**Freightliner
Service Bulletin**

Tire Pressure Monitoring System (TPMS) ECU Relocation and Antenna Addition

40-013

Fig. 2, TPMS Antenna

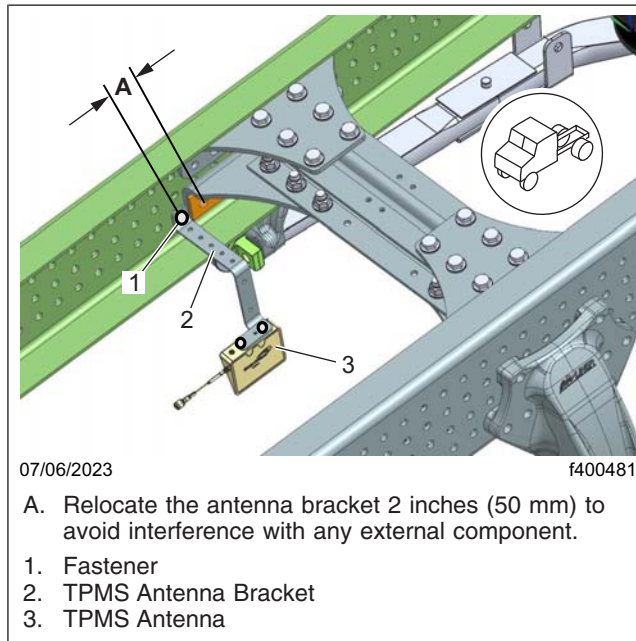
IMPORTANT: Relocate the antenna bracket 2 inches (50 mm), as shown in **Fig. 2**, to avoid interference with any external component.

6. Using the existing fasteners install the new TPMS antenna bracket (06-95363-000) and the TPMS antenna (BW 2400162N), tighten the mounting cap screws 60 lbf-in (678 N-cm). See **Fig. 2**.
